Addendum #05

ADMINISTRATION BUILDING ROOF AND SIDEWALK REPLACEMENT
Salem State University – North Campus
Salem, MA

MASS. STATE PROJECT NO. SSU-2021-A Contract #1
CAMIS NO. J226800
JONES ARCHITECTURE PROJECT NO. 2011

September 07, 2020

DRAWING TITLE:
 REVISED SECTION
 DETAIL AT SEATWALL

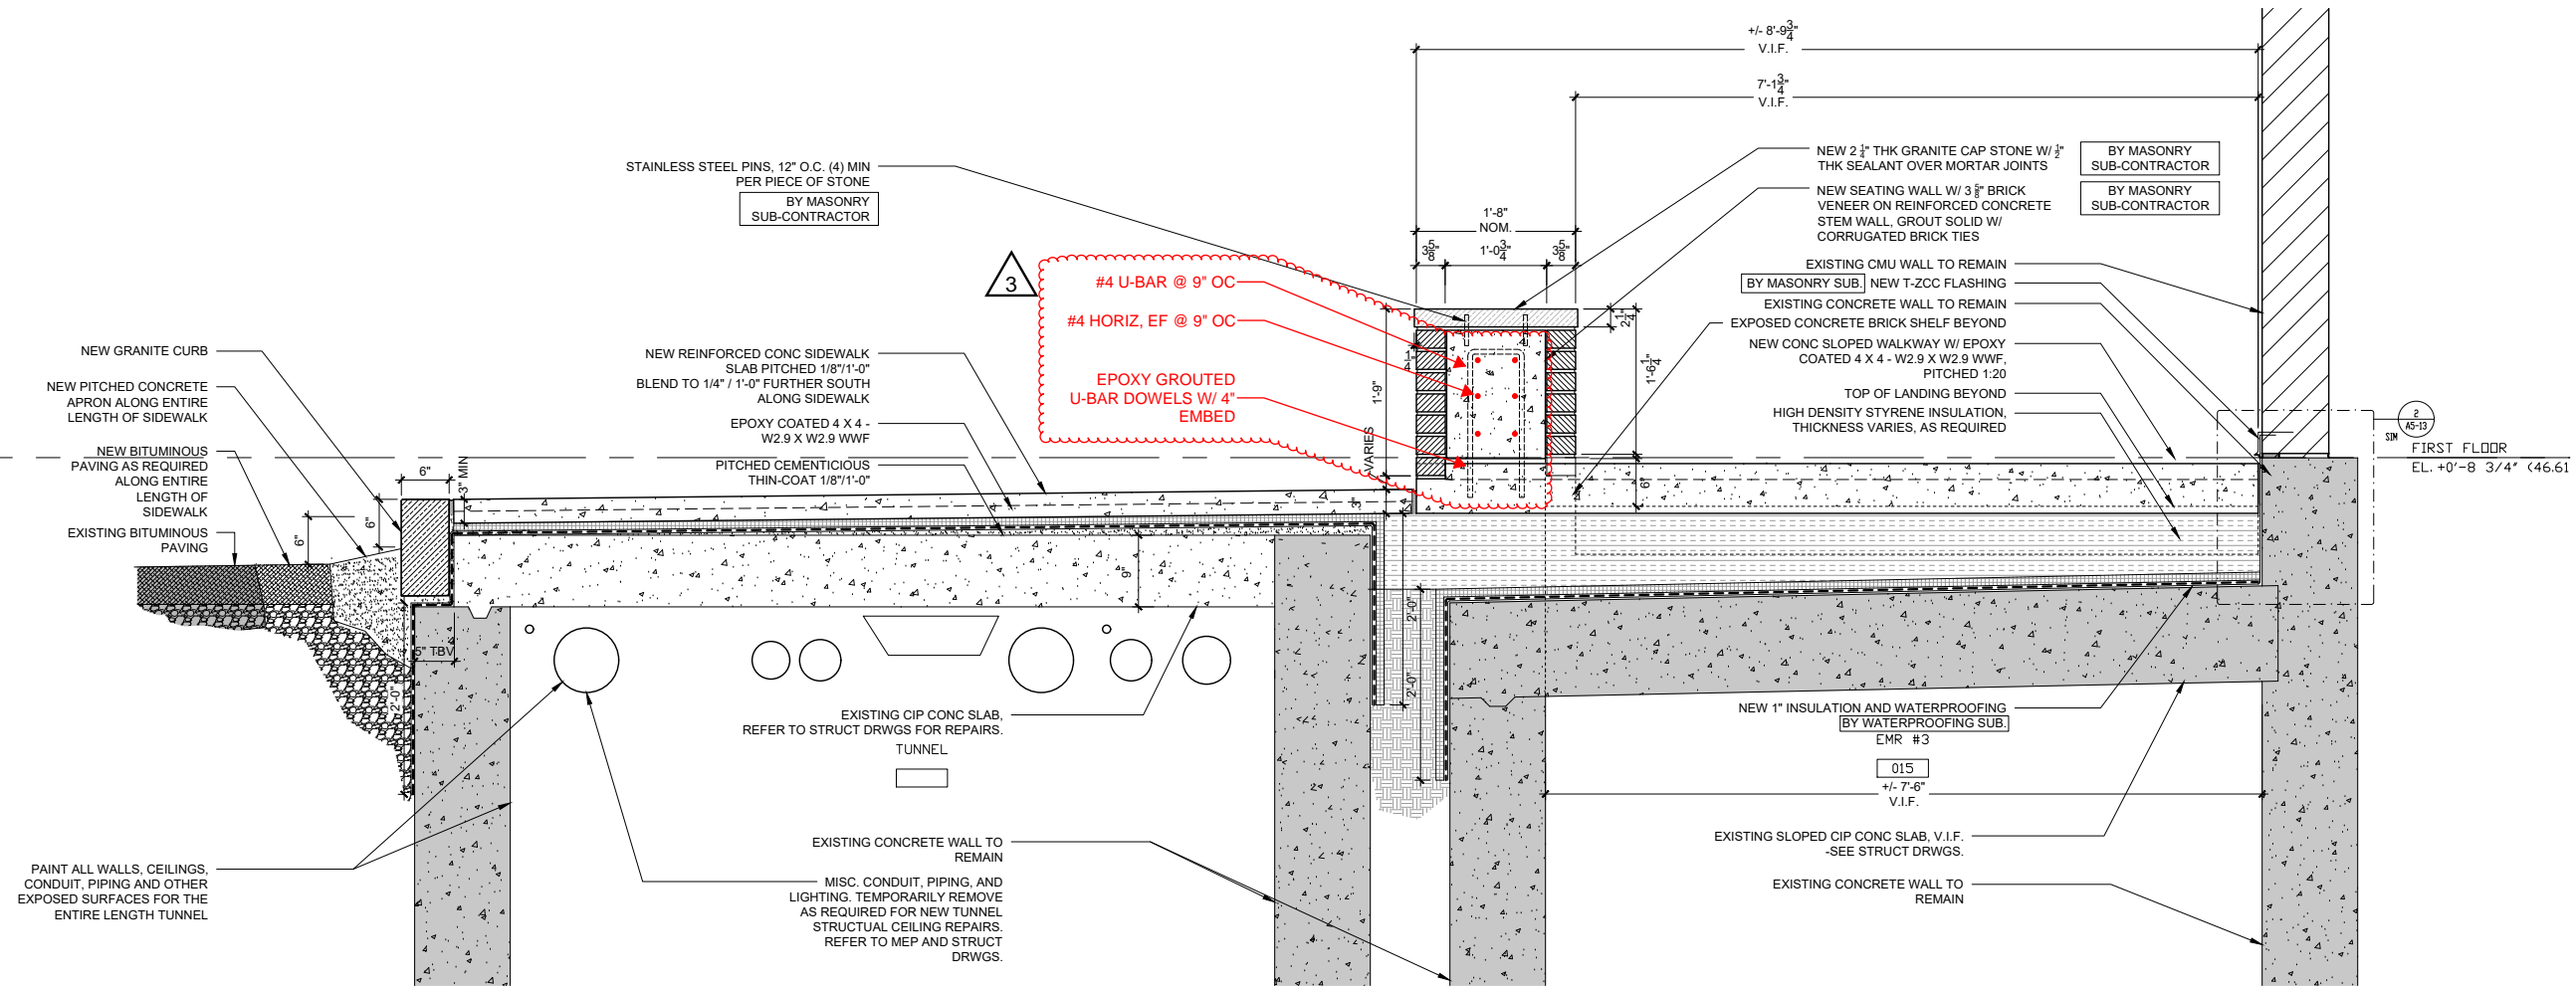
10. Q. REGARDING THE SITTING WALL SHOWN ON A110 AND DETAILS SHOWN ON A513 IS THE CONCRETE SUBSTRUCTURE BY THE GC OR THE MASONRY FILED SUB BIDDER? CAN YOU PLEASE PROVIDE

STRUCTURAL DETAILS ON THIS AS THERE DOES NOT APPEAR TO BE ANY?

A. By GC/Concrete. Additional structural information provided in the attached sketch, SKA-004.

SEE REVISION:
 3 ADDENDUM 5

1 SECTION DETAIL AT SIDEWALK AND ELEVATOR MACHINE ROOM
 1/2" = 1'-0"
